**ADDENDUM NO. 2**

PROJECT TITLE:  
**REPLACEMENT OF  
 BRIDGE NO. 06896, ROUTE 156  
 OVER ARMSTRONG BROOK**

TOWN:  
**OLD LYME**  
 DRAWING TITLE:  
**RIGHT-OF-WAY  
 PLAN**

PROJECT NO.  
**104-175**  
 DRAWING NO.  
**ROW-1**  
 SHEET NO.  
**03.02.A2**

PROJECT NO.  
**104-175**  
DRAWING NO.  
**XSC-05**  
SHEET NO.  
**03.16.A2**

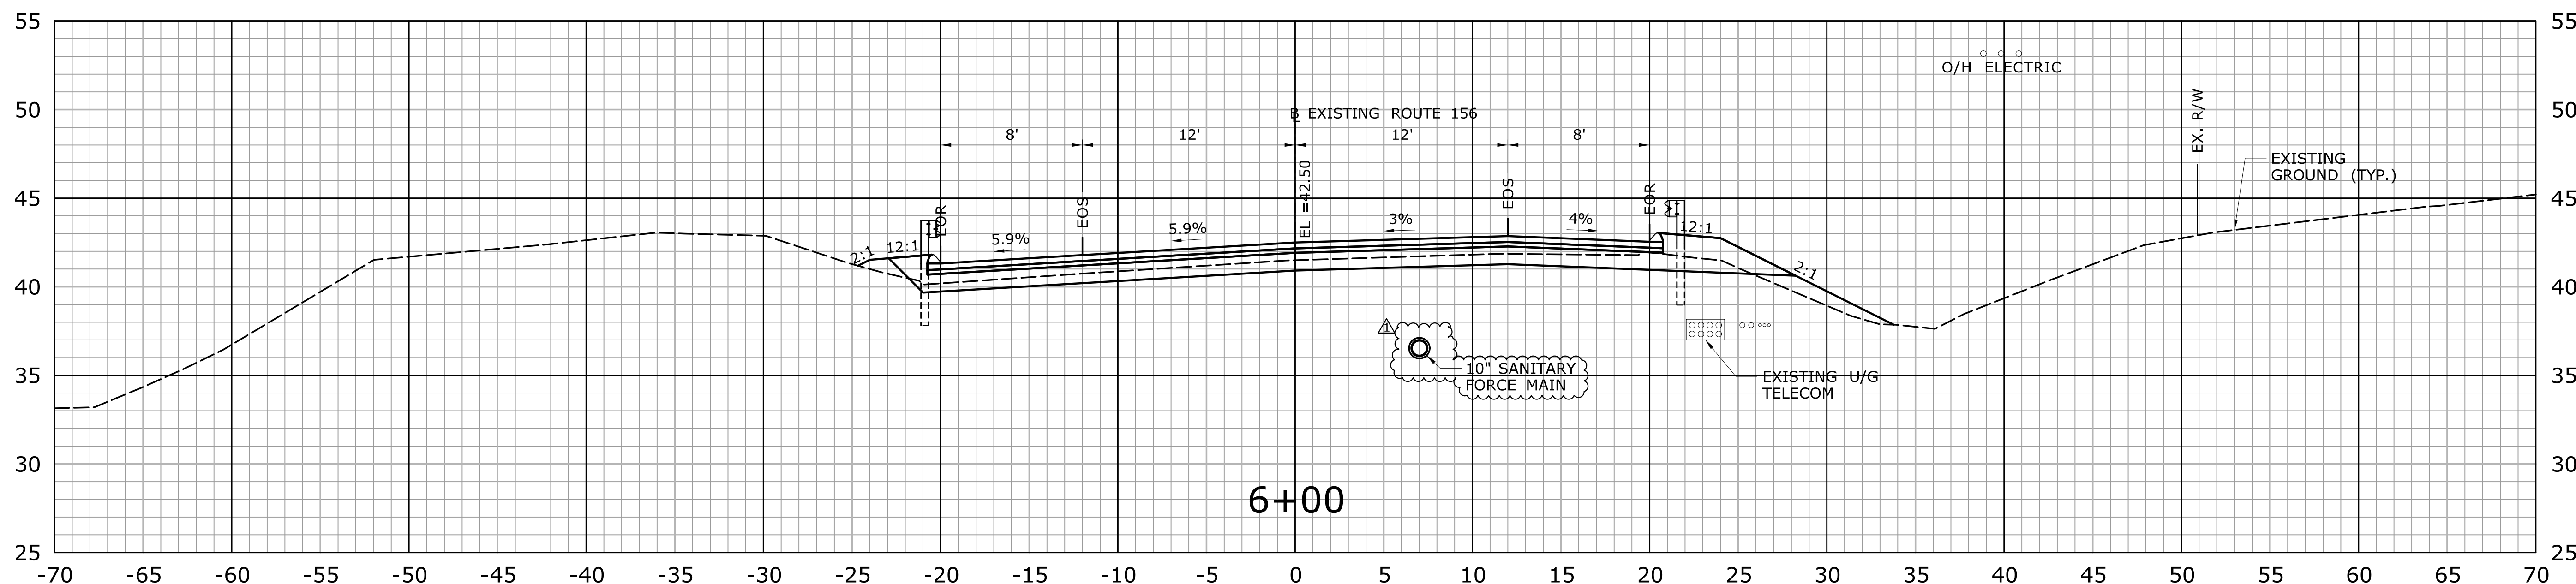
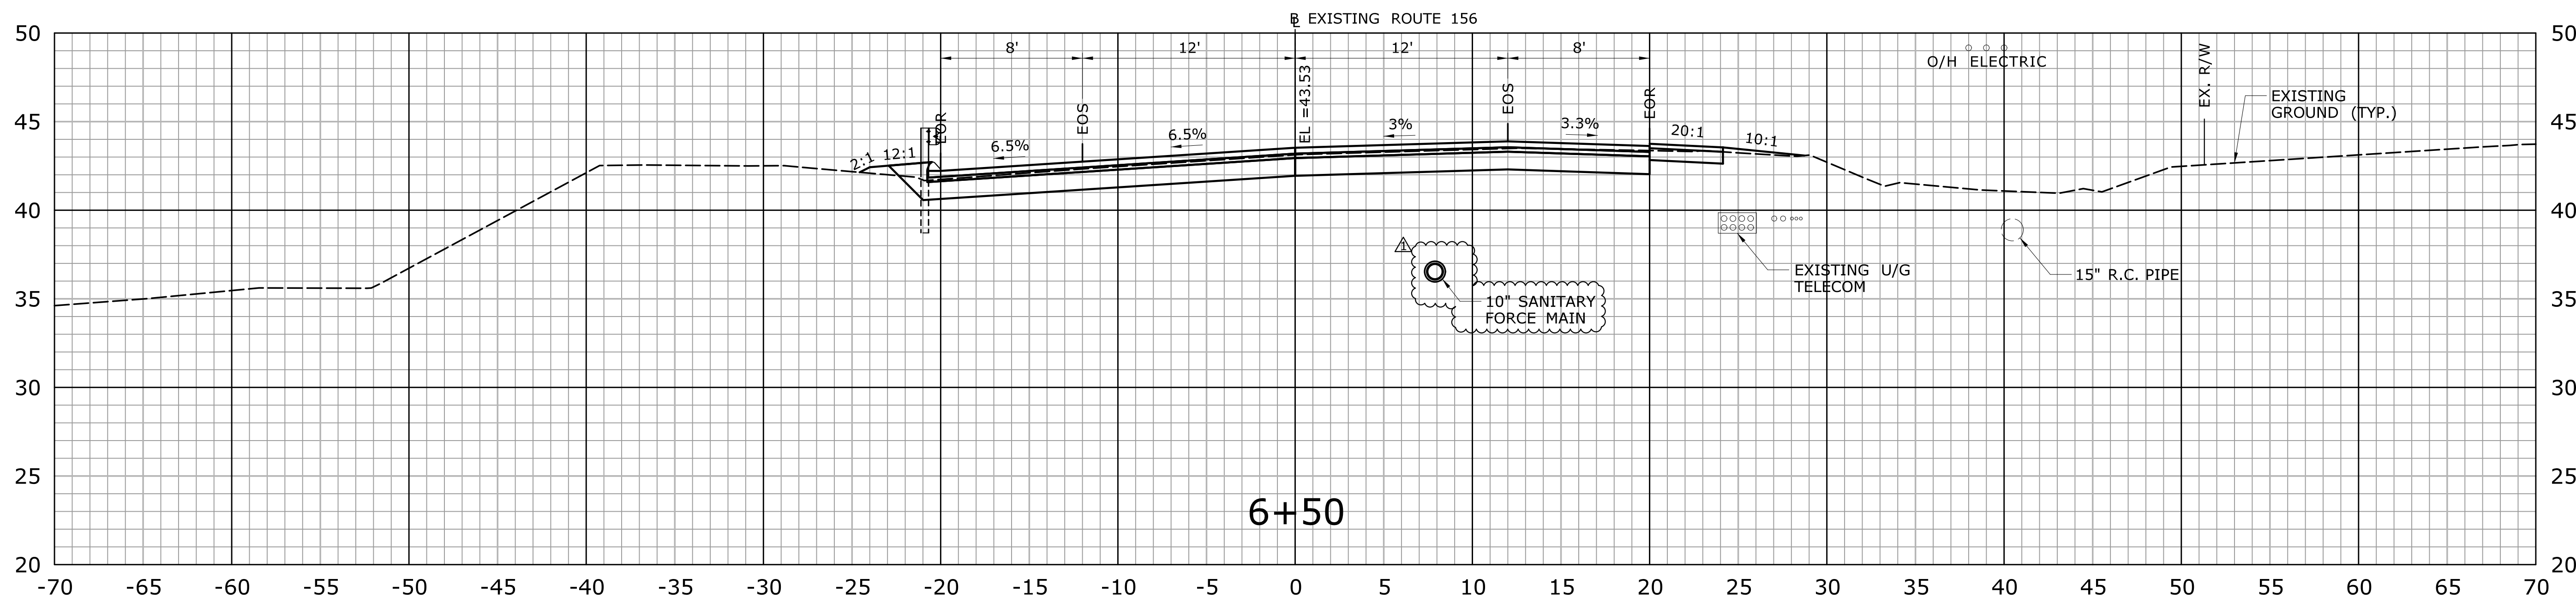
REV.	DATE	REVISION DESCRIPTION	SHEET NO.
1	1.31.25	ADD SANITARY FORCE MAIN	03.16

SHEET NO.  
**03.17.A2**

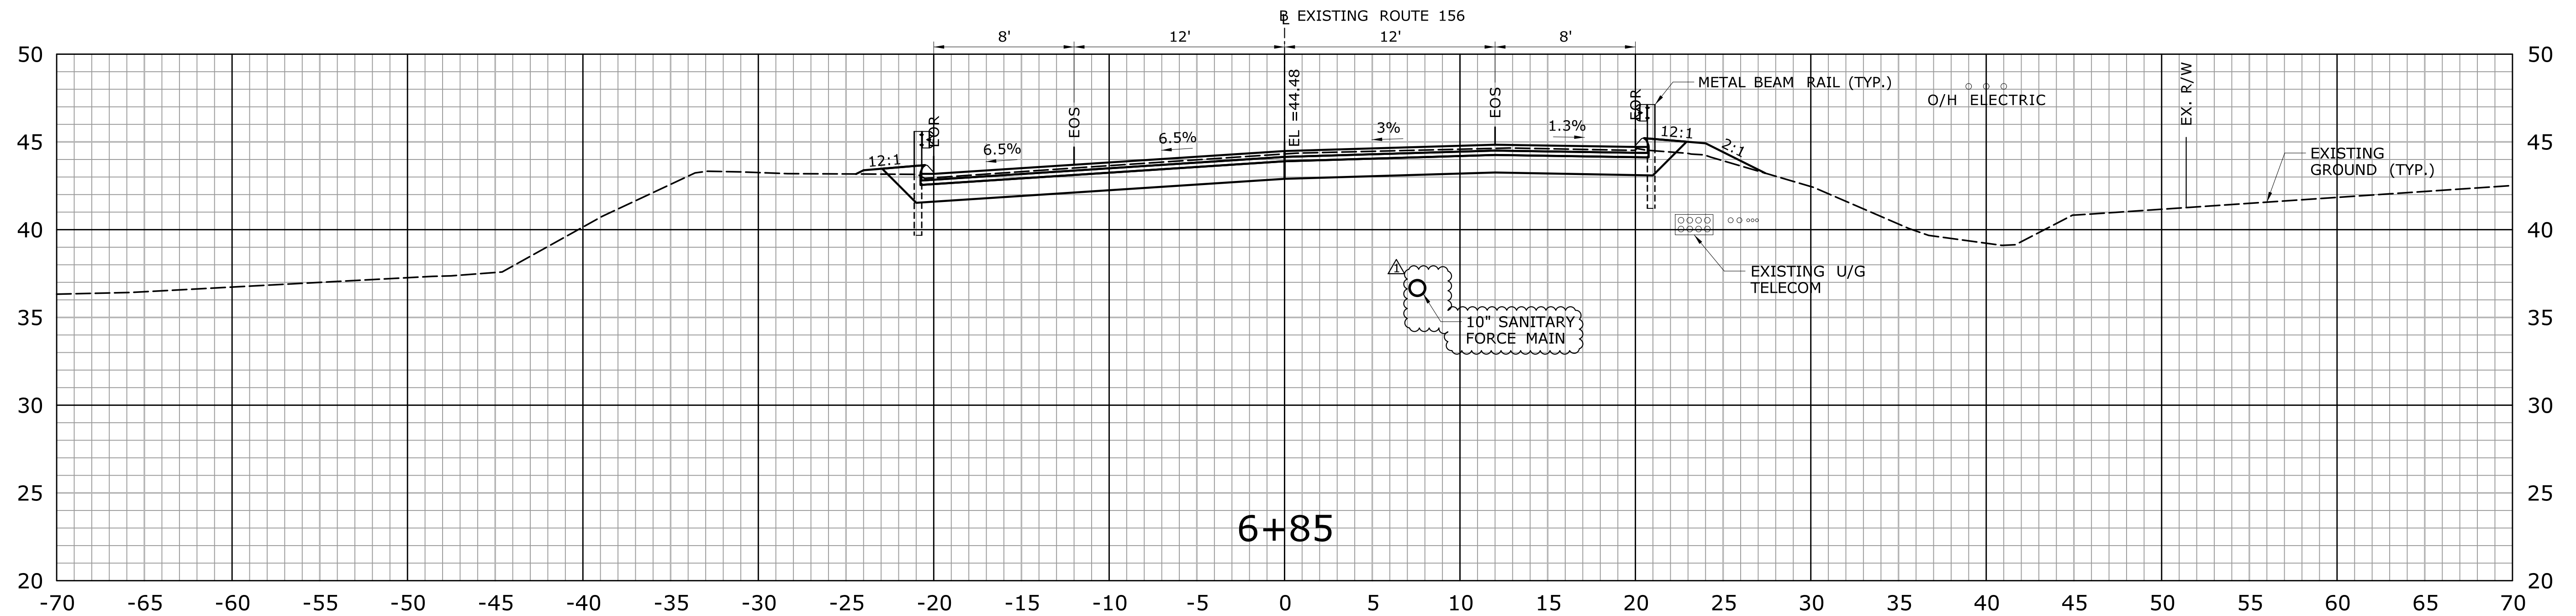
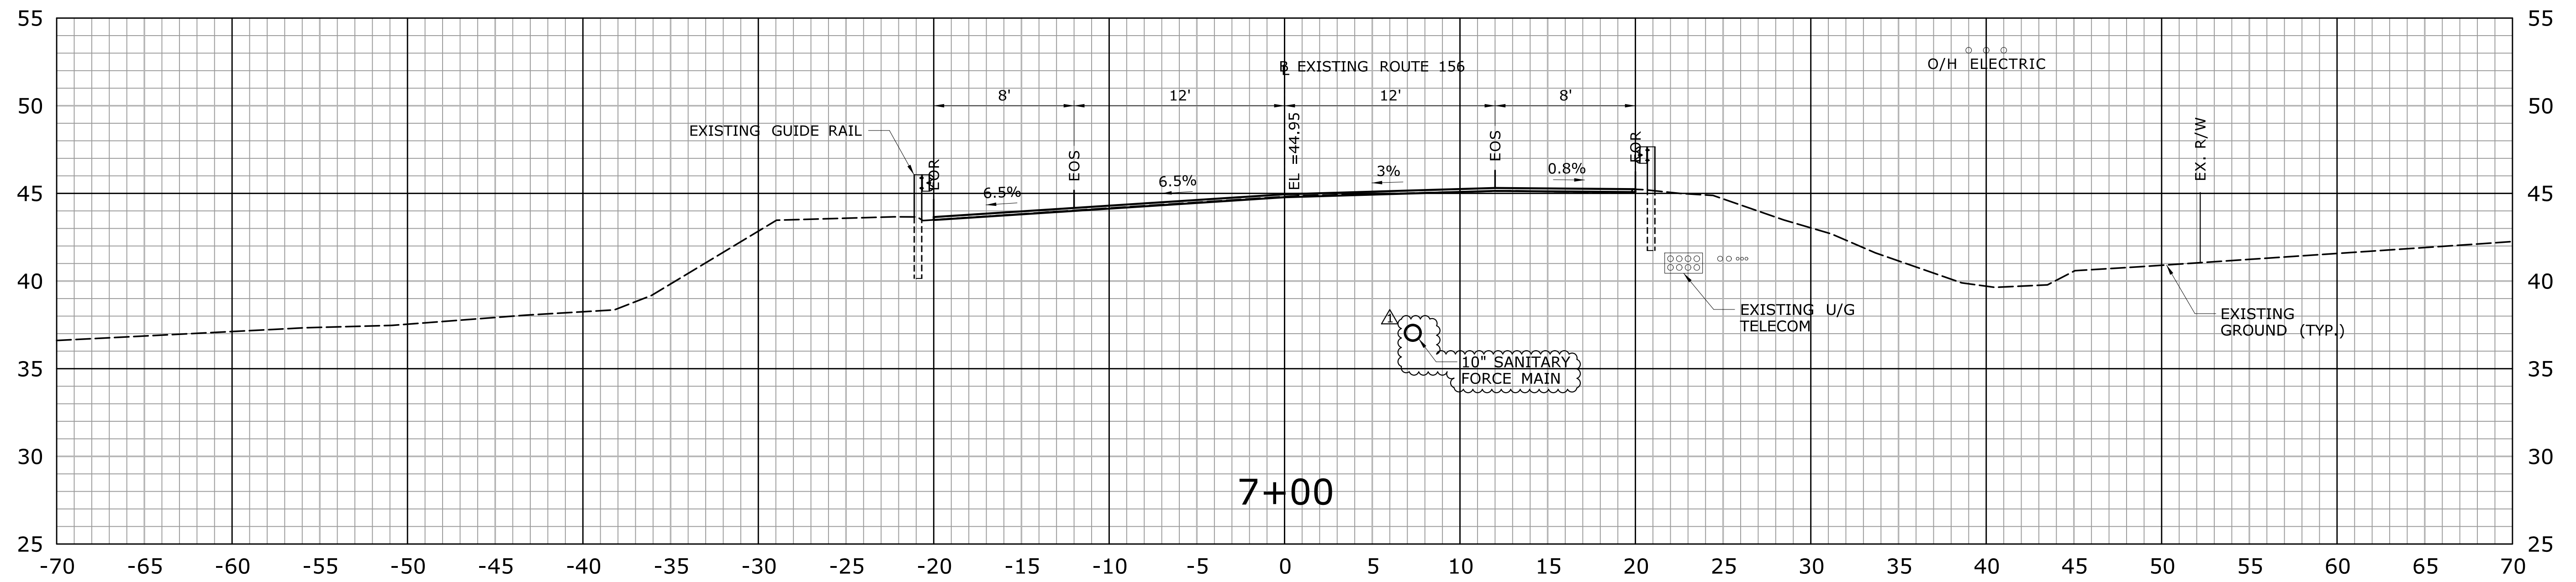
REV.	DATE	REVISION DESCRIPTION	SHEET NO.
1	1.31.25	ADD SANITARY FORCE MAIN	03.17

SHEET NO.  
**03.18.A2**

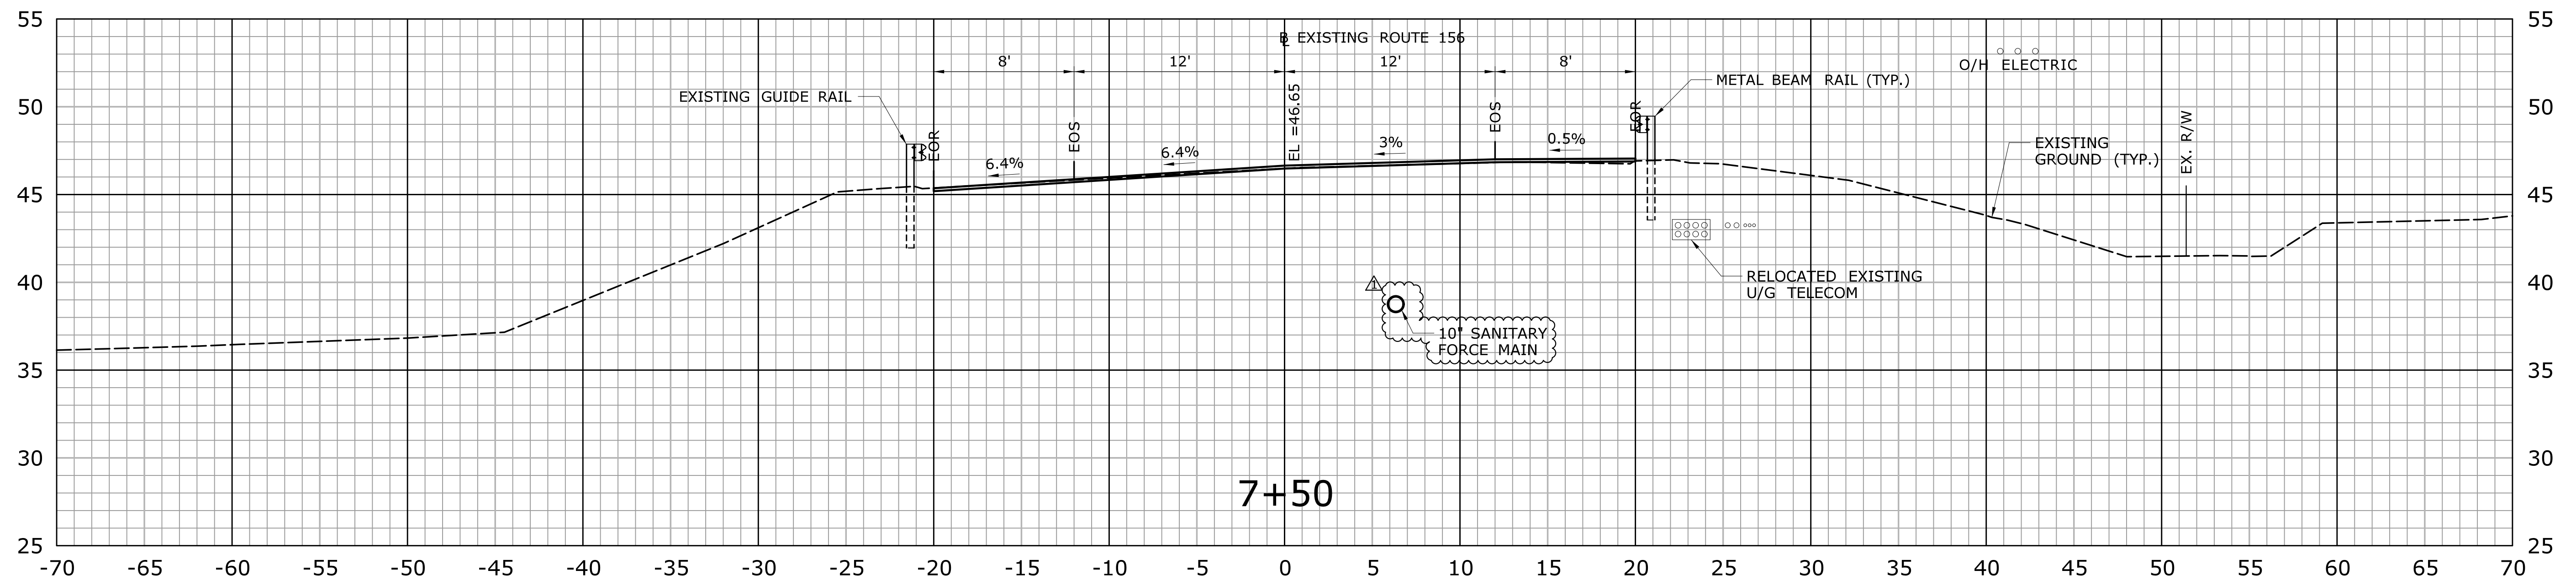
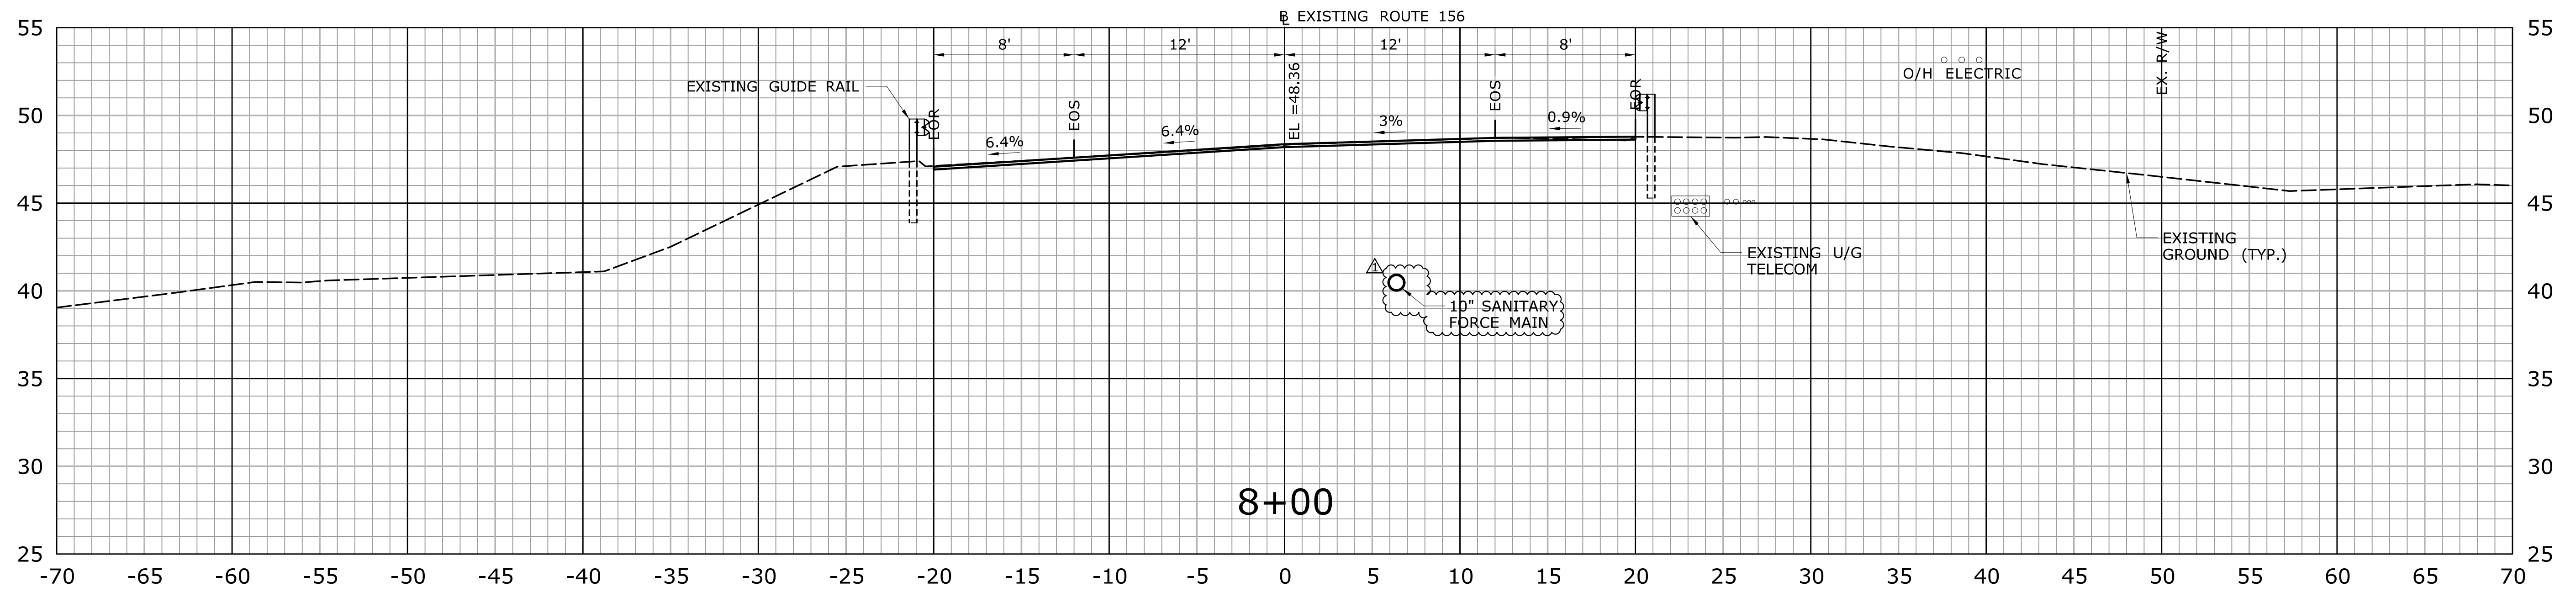
REV.	DATE	REVISION DESCRIPTION	SHEET NO.
1	1.31.25	ADD SANITARY FORCE MAIN	03.18
